ATTACHMENT A: RIVERSIDE COUNTY AIRPORT LAND USE COMMISSION DEVELOPMENT REVIEW

RE: AIRPORT LAND USE COMMISSION (ALUC) DEVELOPMENT REVIEW

File No.: ZAP1052RI11
Related File No.: PSP 11-0027 "RTRP 69 kV" (Environmental Impact Report)
APN: Primarily in Public Rights-of-Way

RE: Case Number: ZAP1052RI11 – City of Riverside Public Utilities

FIGURE 1

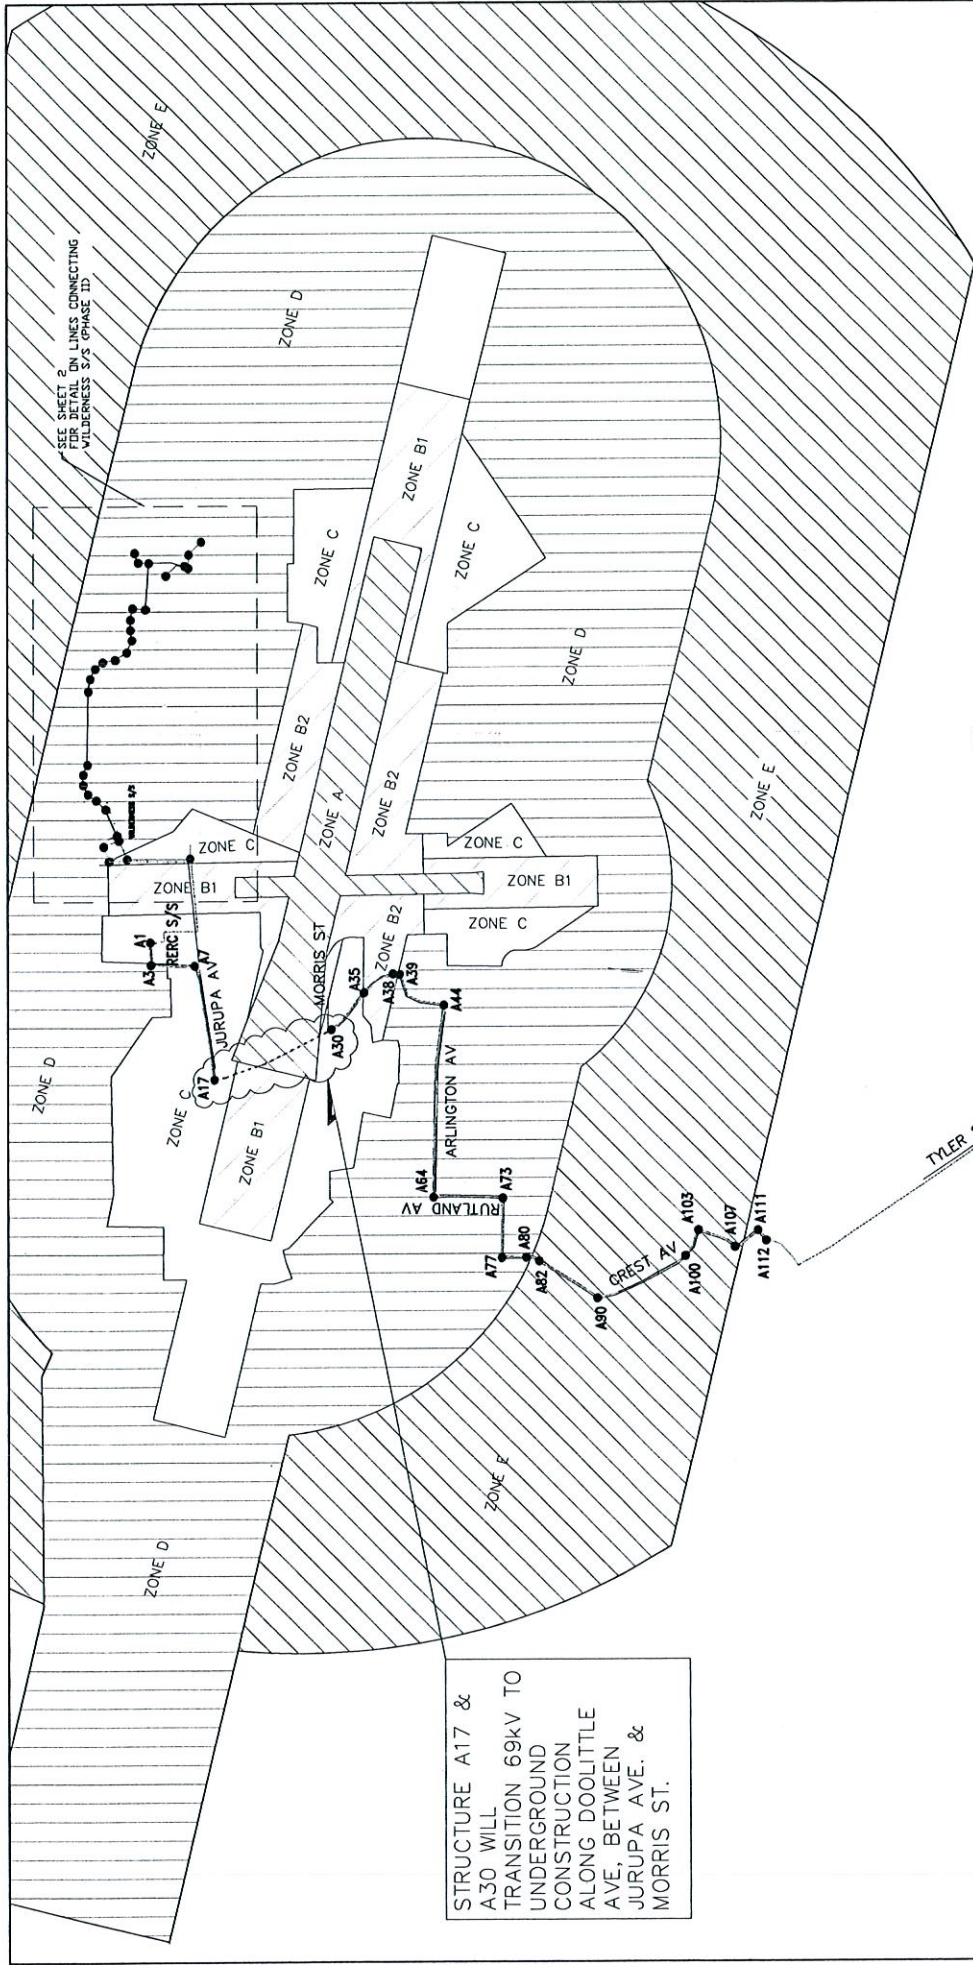
SEE SHEET 2 FOR DETAIL ON LINES CONNECTING WILDERNESS S/S (PHASE 1D).

STRUCTURE A17 & A30 WILL TRANSITION 69KV TO UNDERGROUND CONSTRUCTION ALONG DOOLITTLE AVE, BETWEEN JURUPA AVE. & MORRIS ST.

FIGURE 2

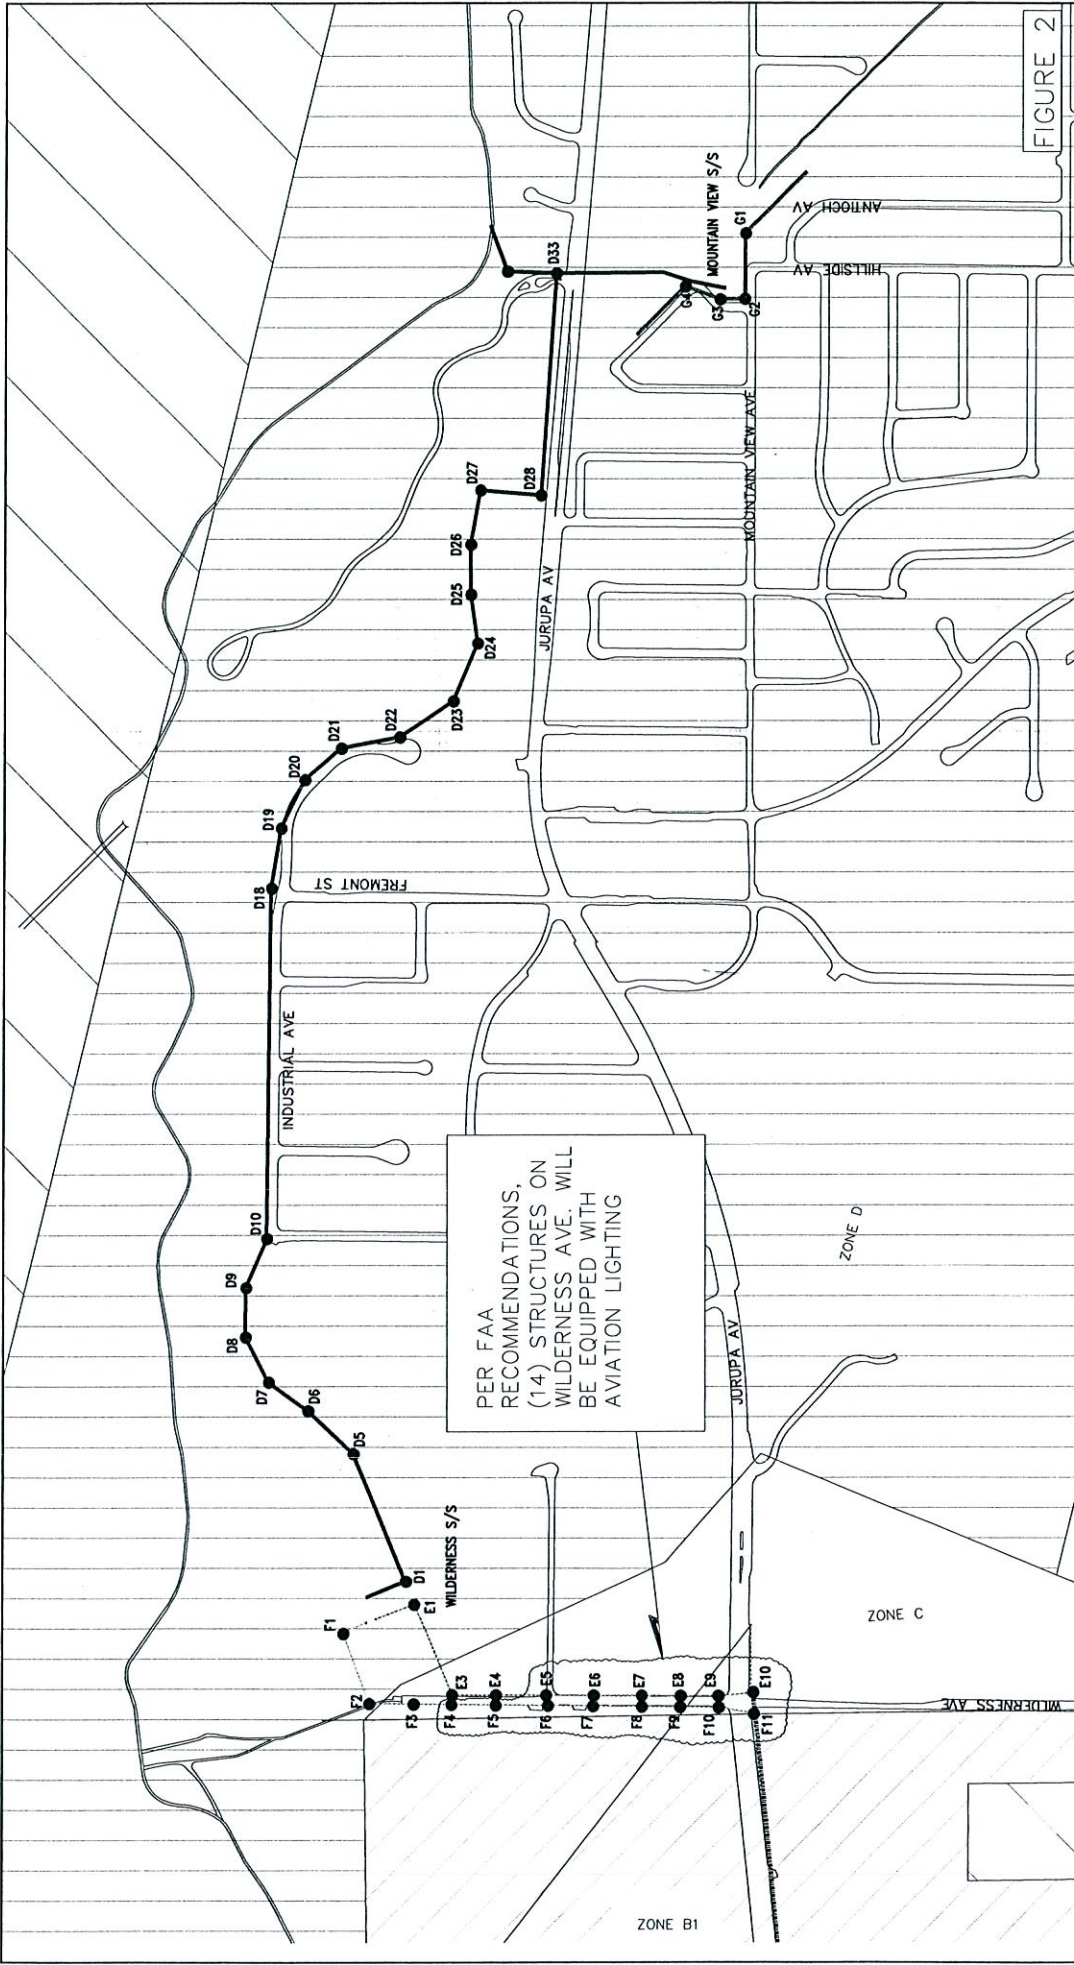
The 14 structures, along Wilderness Avenue and at the intersection of Wilderness and Jurupa Avenues, will be equipped with aviation lighting, including Structure F11 mentioned above (see Figure 2).

PER FAA RECOMMENDATIONS,
 (14) STRUCTURES ON
 WILDERNESS AVE. WILL
 BE EQUIPPED WITH
 AVIATION LIGHTING
